# CITY OF MILWAUKIE

### PLANNING COMMISSION

4.1 Summary: Continuation of Railroad Avenue Subdivision  
Applicant: I&E Construction, Inc.  
Address: Vacant lot on Railroad Ave between Stanley Ave and Beckman Ave  
File: S-2018-001  
Staff: Mary Heberling, Assistant Planner

Figure 2: Updated Mitigation Plan

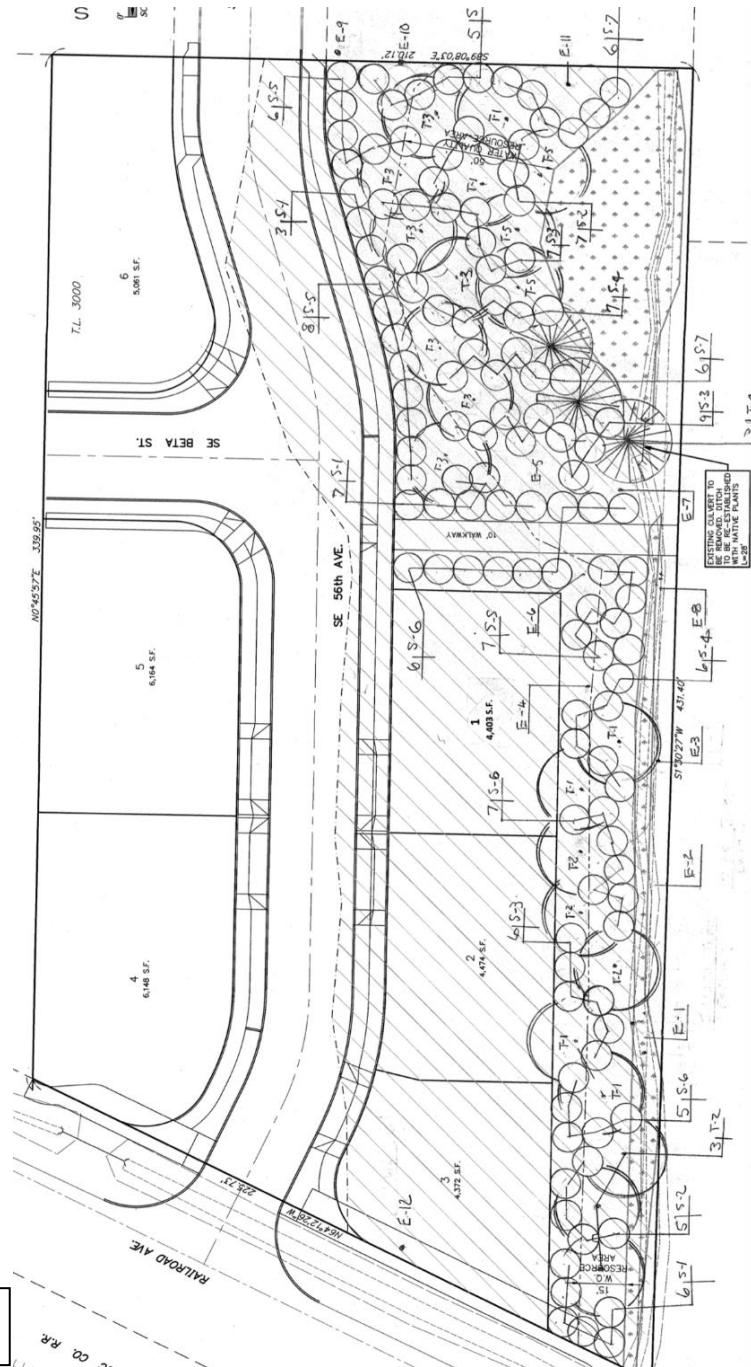
City staff had Julian take a look at the updated mitigation plan and his comments can be found in Attachment 6. In particular, staff asked Julian to take a look at the proposed tree canopy to see if it could be increased, whether plantings in the wetland were appropriate, and if the plantings along the pedestrian path would provide enough shade. Julian's comments were given to the applicants who have made updates to the Mitigation Plantings Plan (See Attachment 4). The new Mitigations Plantings Plan (Figure 3) shows the changes made based on Julian's comments. They are also listed below.

- Increased tree canopy within the natural resource tract.
- Tree plantings shown at 20 ft on-center.
- The addition of Oak and Ponderosa Pine trees.

Figure 3: Updated Mitigations Planting Plan

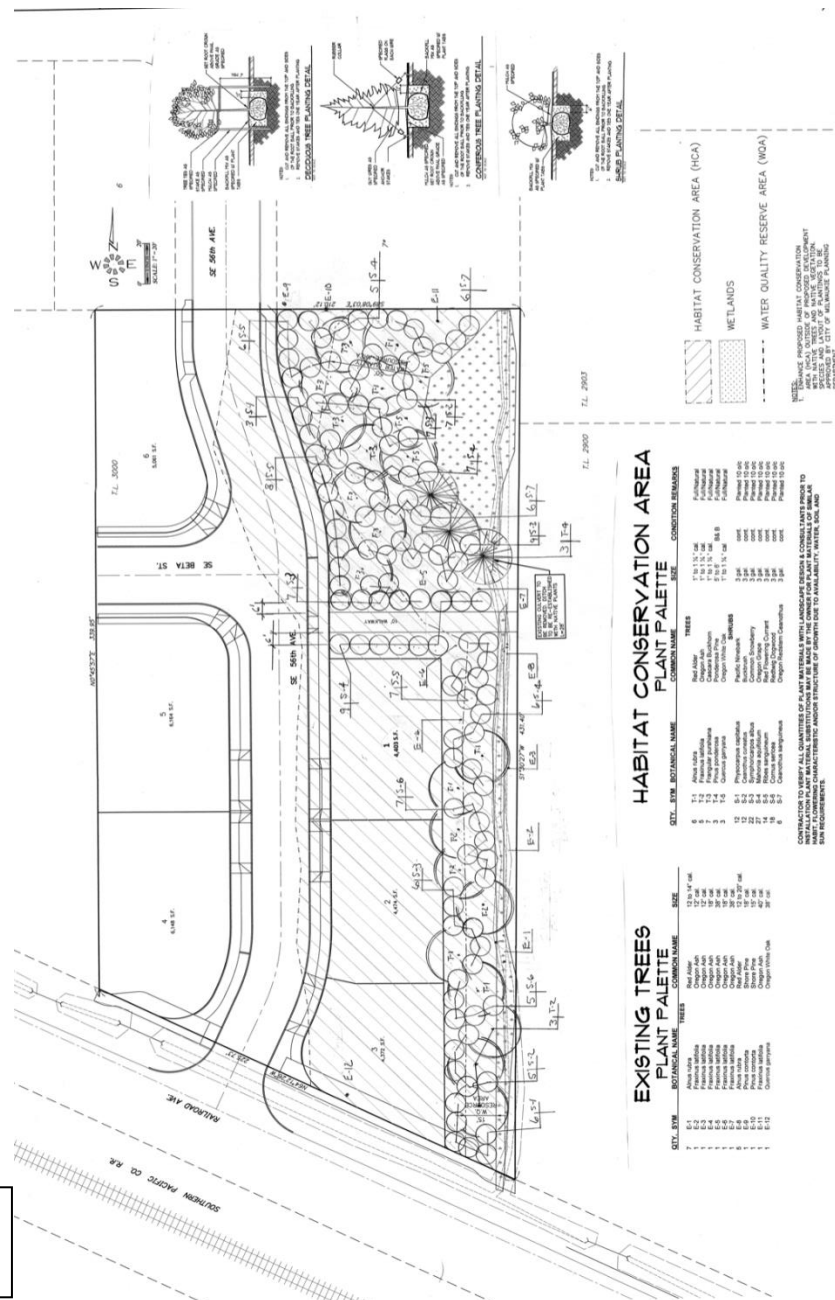
Julian also provided comments on the shrub species planted around the pathway. He said that shrub species S-1 (Pacific Ninebark), S-5 (Red Flowering Currant), S-6 (Redtwig Dogwood) should be planted at least six feet back from the sidewalk/path edge, as they can be a pruning problem once full grown. If plants are needed closer than that, S-3 (Common Snowberry) is a good option.

For planting within a wetland, Julian commented that planting trees in a wetland zone is fine, so long as the water level is, at least, a couple inches below the surface at the time of planting. He approves of the smaller stock as it's not a street side planting and digging smaller holes in the wetland is preferred. Plants with a one-inch caliper minimum and a minimum of five-feet in height is appropriate. He also recommends larger shrubs (3 gal. instead of 2 gal.).

Julian’s final suggestion is to substitute other plants for the seven *Cornus nutallii* (*Pacific Dogwood*) as they’re difficult to establish, and susceptible to anthracnose infection. He suggested they plant *Frangula purshiana* (*Cascara buckthorn*) as in the previous plans or plant more oaks and pines.

Response: The applicant has Common Snowberry along the northeastern portion of the pathway, closer to the roadway 56<sup>th</sup> Ave. Redflowering Currant is still along the southwestern portion of the pathway, but it is not directly next to Lot 1 where pruning issues could be a problem and closer to the intermittent stream natural area. See Figure 3 or Attachment 4.

Response: The applicant has increased the size of the shrubs to 3 gallons. The proposed trees now have calipers of 1-1 ¼ inches and the Ponderosa Pine to reach 5-6 ft high. See Figure 3 or Attachment 4.

Response: The applicant has replaced Pacific Dogwood with Cascara Buckthorn. See Figure 3 or Attachment 4.
